# City of Sandy

### Planning Commission Meeting

**Meeting Date:** June 10, 2019  
**From** James Cramer, Associate Planner  
**SUBJECT:** 18-046 DR/VAR Stow-A-Way Mini Storage

Christopher Warnock with C.W. Real Estate Co., Inc. submitted an application for a Type II Design Review that includes the following five (5) Design Deviations and two (2) Special Variances:

**STORM PLAN**

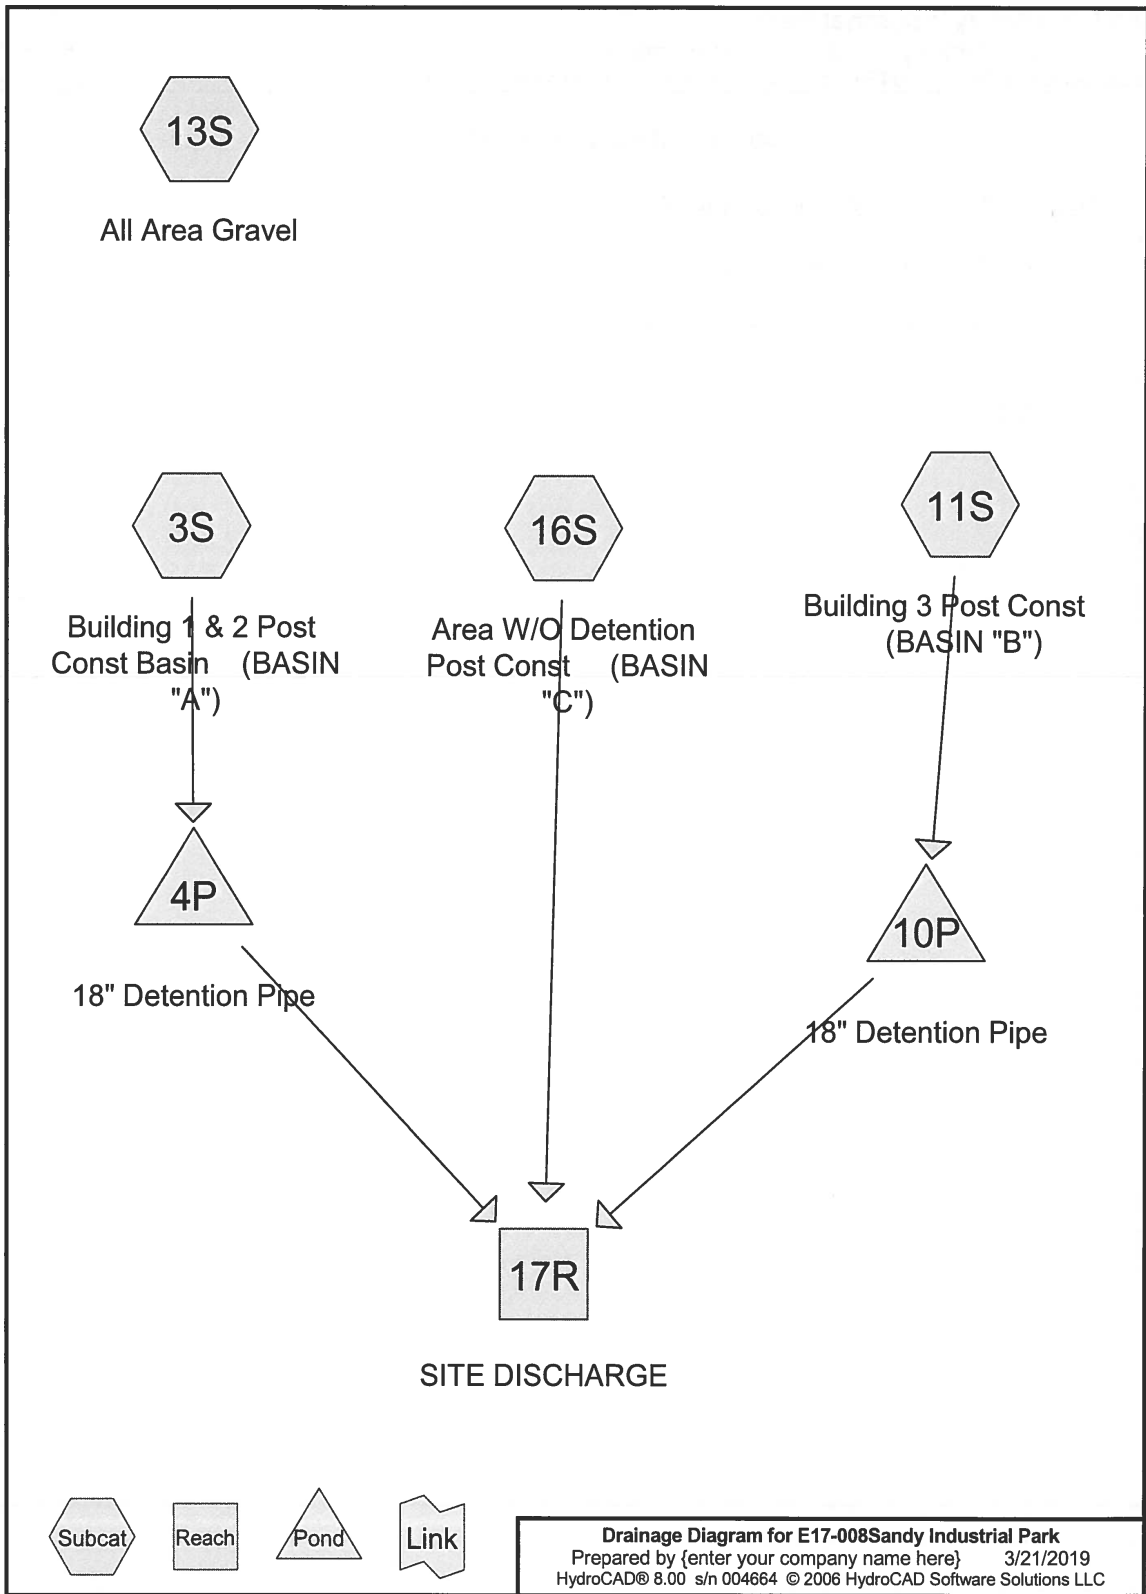
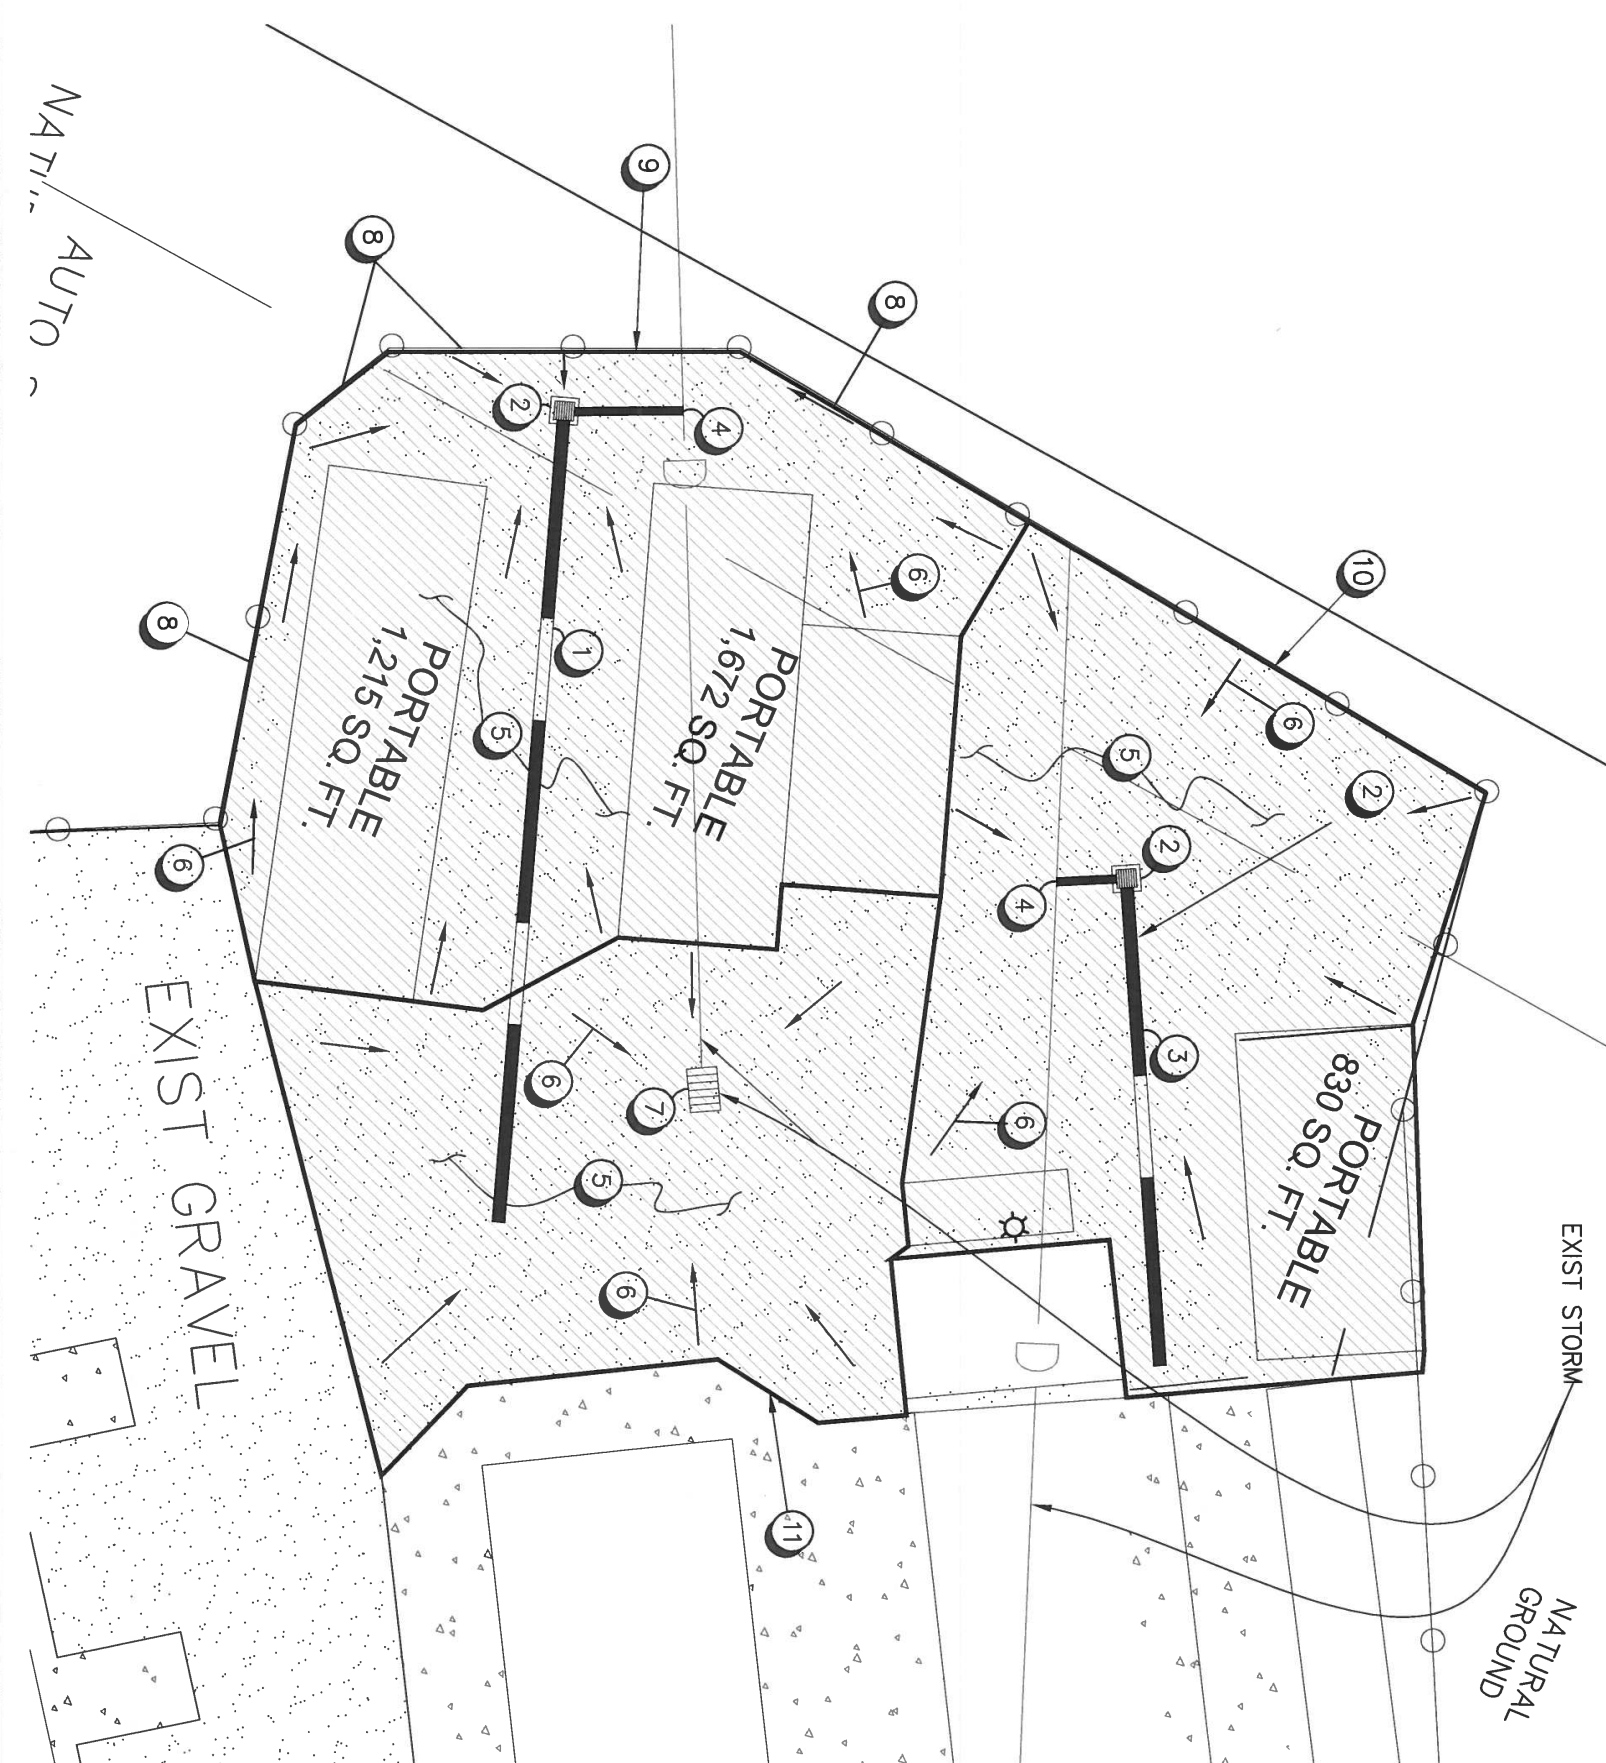
***Prior to submittal of a final drainage report the applicant shall update the site description to include the site area as it is currently shown as “X” as well as provide a map delineating the different basins on the subject property.***
